SR 167/I-5 TO SR 509 – NEW EXPRESSWAY PROJECT DESIGN-BUILD PROJECT

Appendix C – Details of Technical Approach and Innovations

ATC #3 – NB I-5 Alignment Shift for MOT

ATC 005 Rev2 – Response to WSDOT Review Comments Round 2

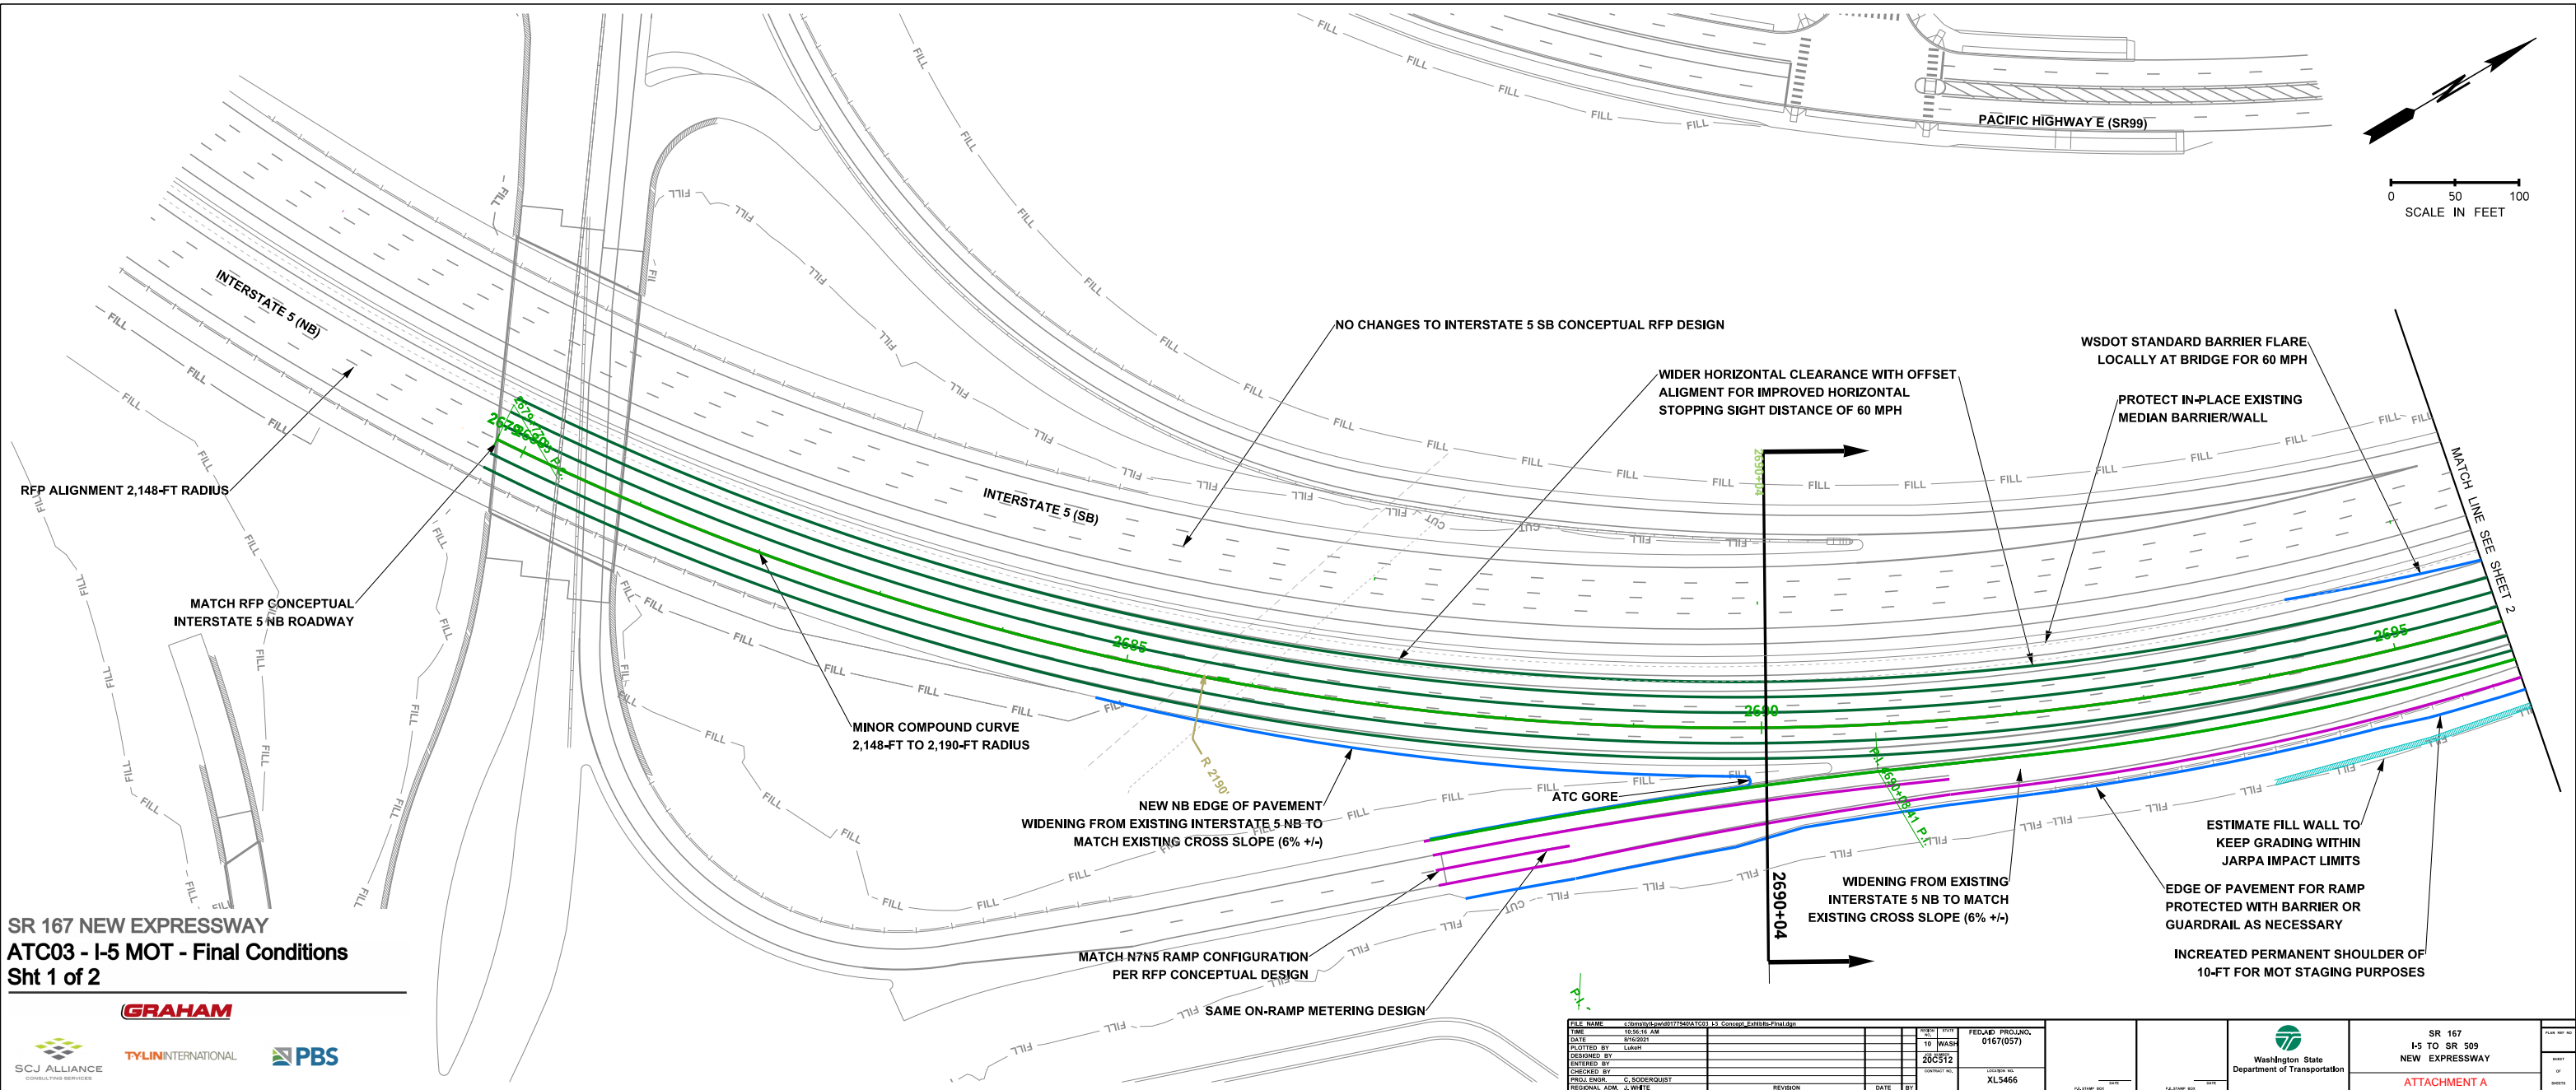
- In Attachment B, many of the legends are mislabeled.

Assume comment is referring to typos in Attachment B. Will correct typos in Attachment B.

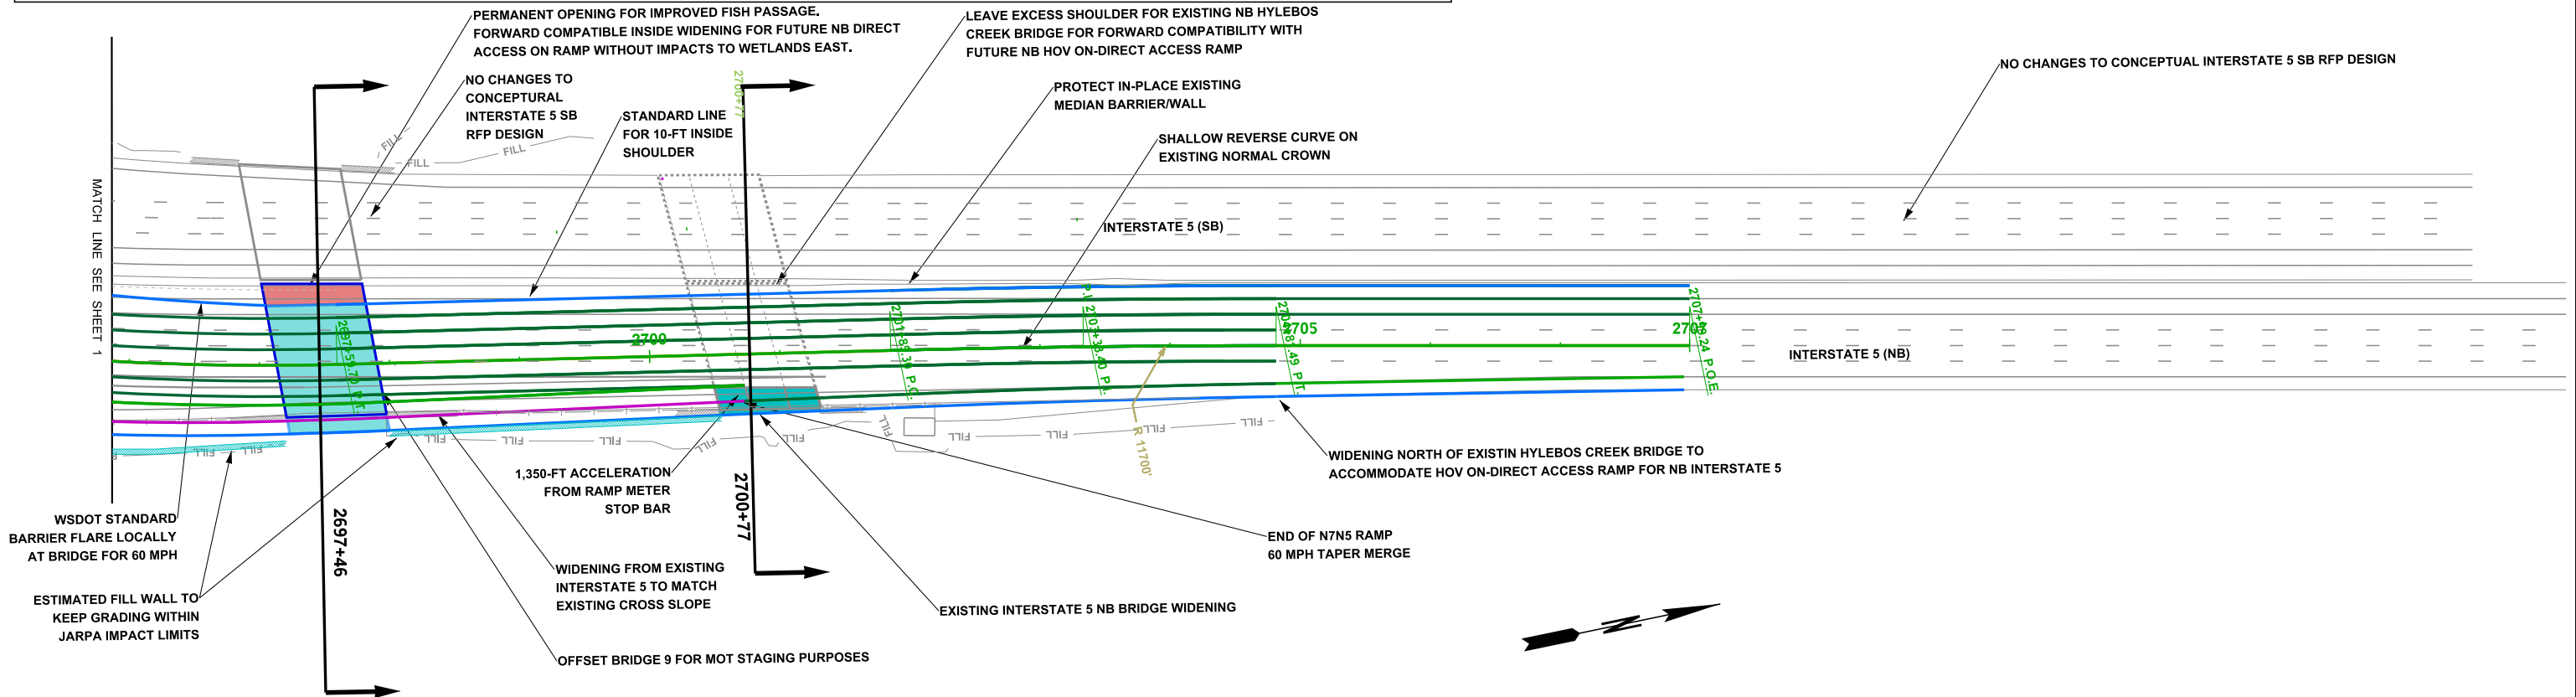
- Note that temporary median concrete barrier must be anchored where less than 3 ft. shoulder width is provided.

Noted. Barrier will be pinned where 3 ft of slide isn't provided. Note defining this on median barrier for crossover in typical sections.

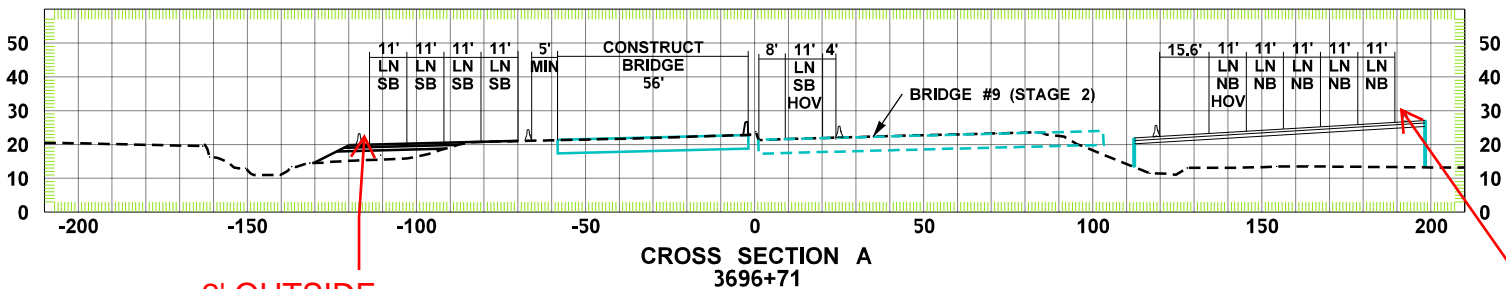
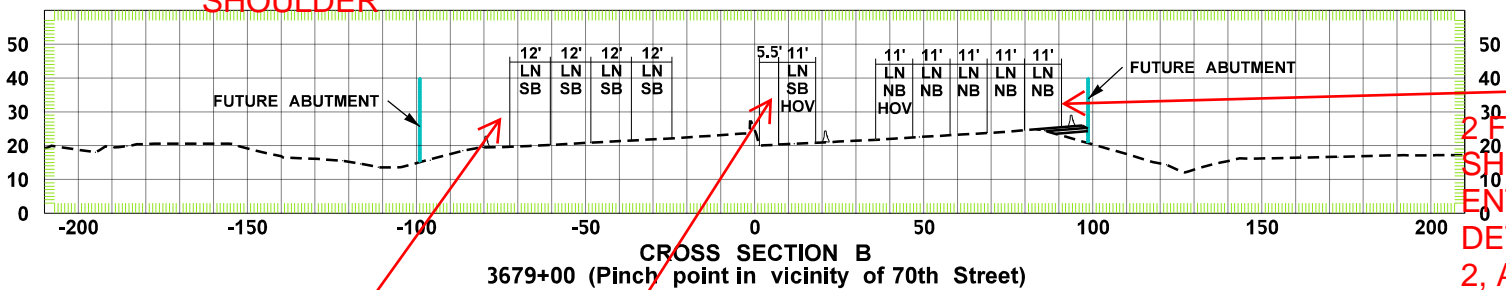
- The use of 2 ft. shoulders for extended distances, especially on the right shoulder is not equal to WSDOT's concept. Please provide an assessment of the length of 2 ft. shoulders of both left and right shoulders for each direction as compared to the WSDOT concept.

WSDOT concept doesn't give specifics online work and overall design based on PDF and two sections. Assumed shoulder comparison is provided in Appendix D for right shoulders. Note that TR's state provide 8 ft min shoulder when feasible with 2 ft minimum.

2' FT INSIDE NB
SHOULDER - ATC
03 2-8 FT INSIDE
SHOULDER

LOCALIZED
PULLOUT OF 10 FT
SHOULDER FOR
ATC03 - SHOULDER
VARIES

ATC 03 provides 8 ft
min shoulder for
stalled vehicles ON
ALL CROSSOVERS

SR 167 I-5 TO SR 509 NEW EXPRESSWAY
CONCEPTUAL PLAN-TEMP. BRIDGE NO. 5/462T

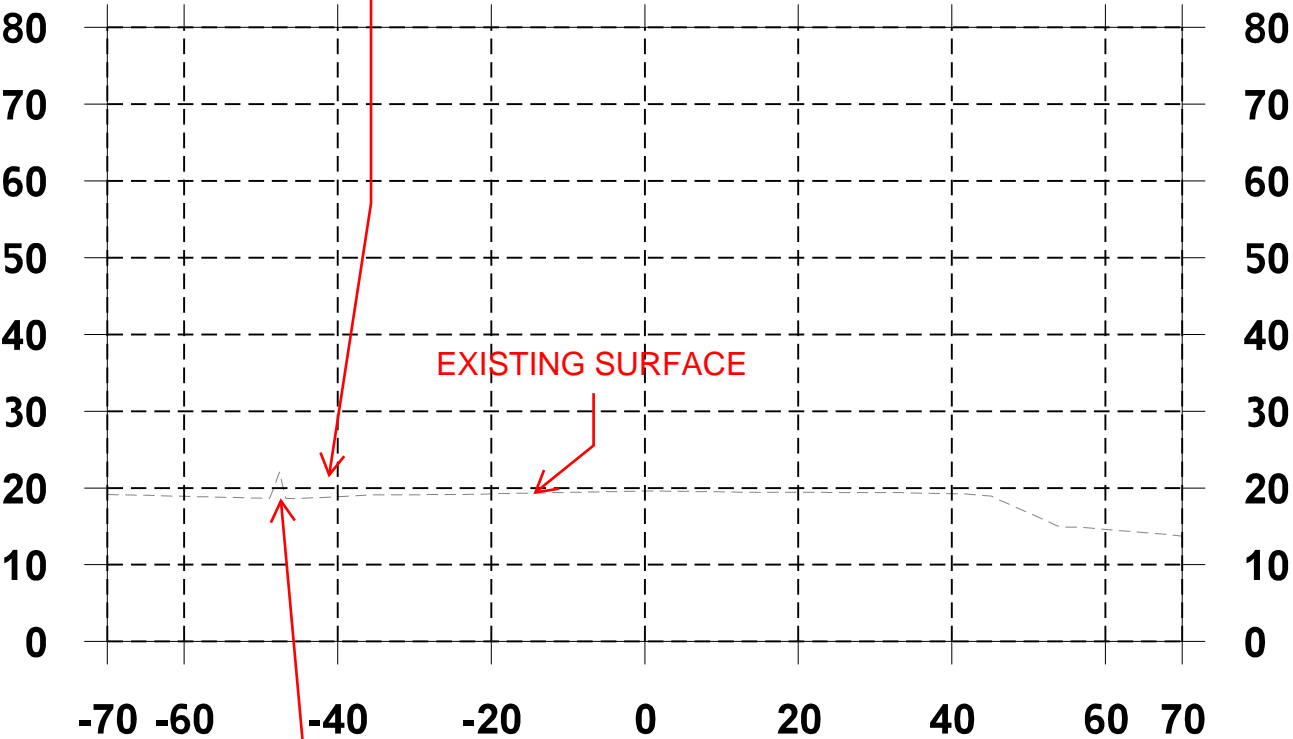
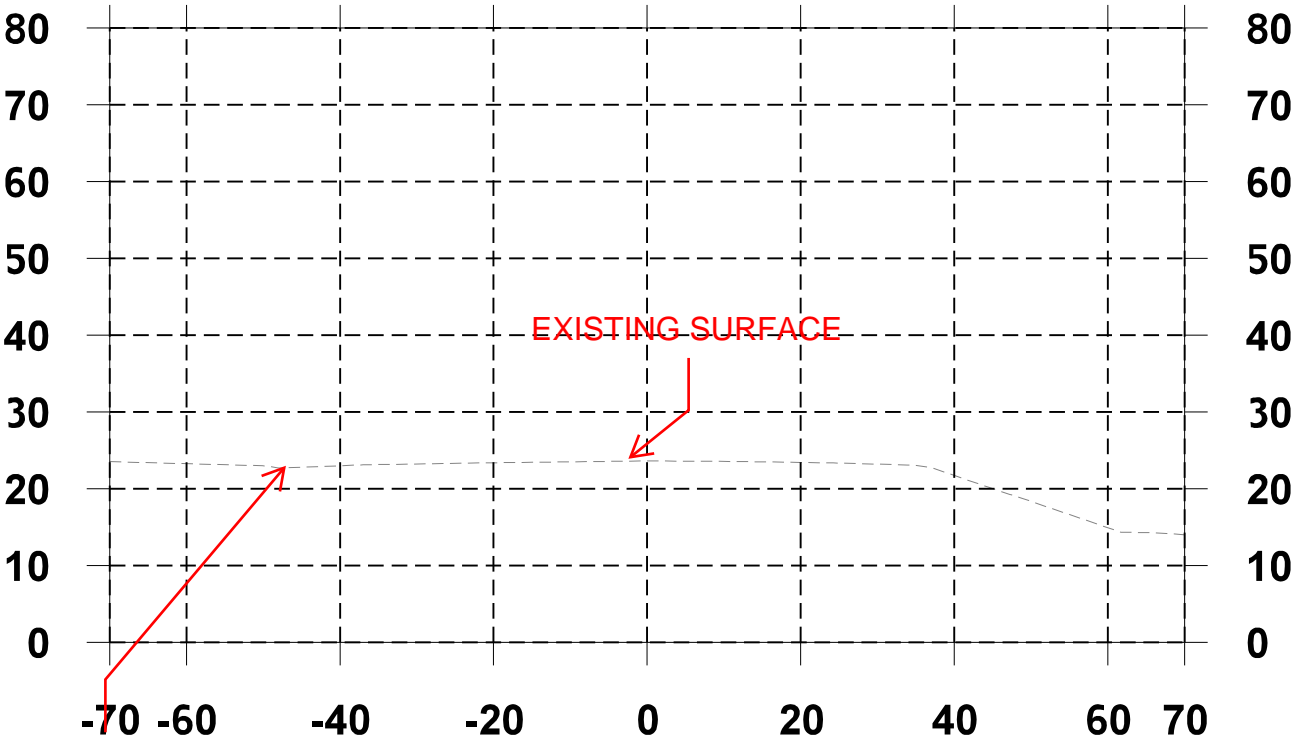
- The location of the southern crossover point of the I-5 median is in conflict with the median retaining wall which ends approximately 280' south of the spiral curve. This location is visible in the existing topo MicroStation file. Please adjust your plans accordingly.

- The crossover at the south will be adjusted 280 south as noted to eliminate this issue per WSDOT comment. See updated plans for further information. Crossover for both NB and SB at the southern limits pushed fully back from I-5 Line 3663+30 which is around 300 ft south of Begin of Spiral at 3666+38.15 per supplied alignment base file of existing I-5 alignment. All crossovers are completed before 3663+30 in response to comment.

PER WSDOT COMMENT - SOUTH
CROSS OVER SHALL BE SOUTH OF I-5
3663+30

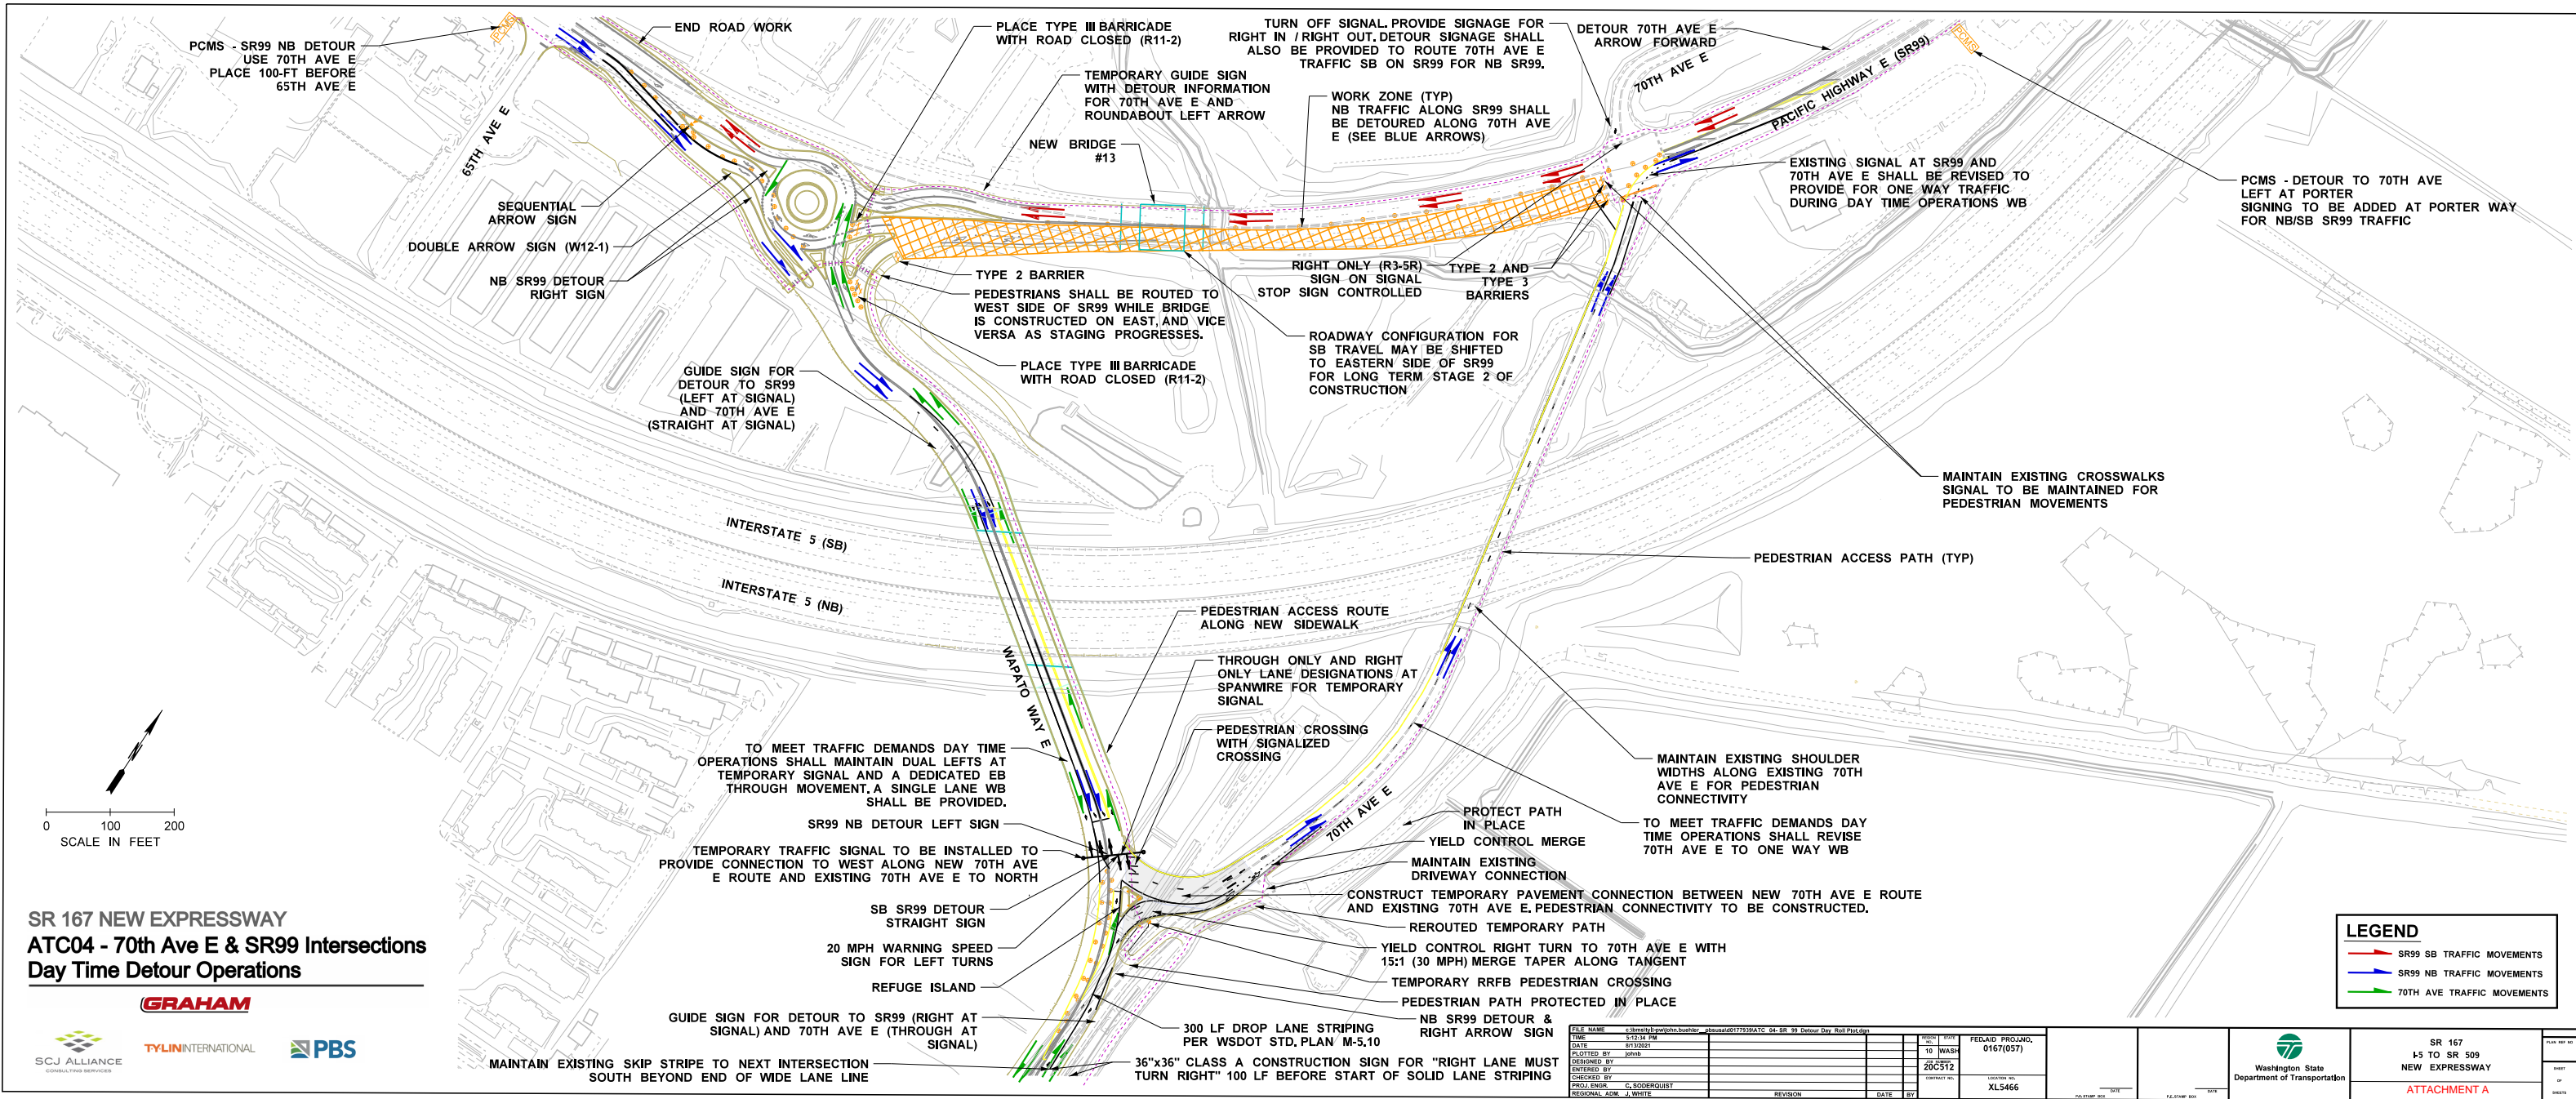
- In the Proposed RFP modifications, there appears to be a couple of typos and it needs to be clarified that the ATC proposal would utilize a single lane closure for both northbound and southbound SR 99 and then route both directions of travel through the detour during select hours as verified by the traffic analysis.

Will fix and clarify statement and define hours to night-time closure hours listed TR's. Clarified core of RFP modifications to hopefully better clarify intent of TR changes. See proposed RFP modifications.
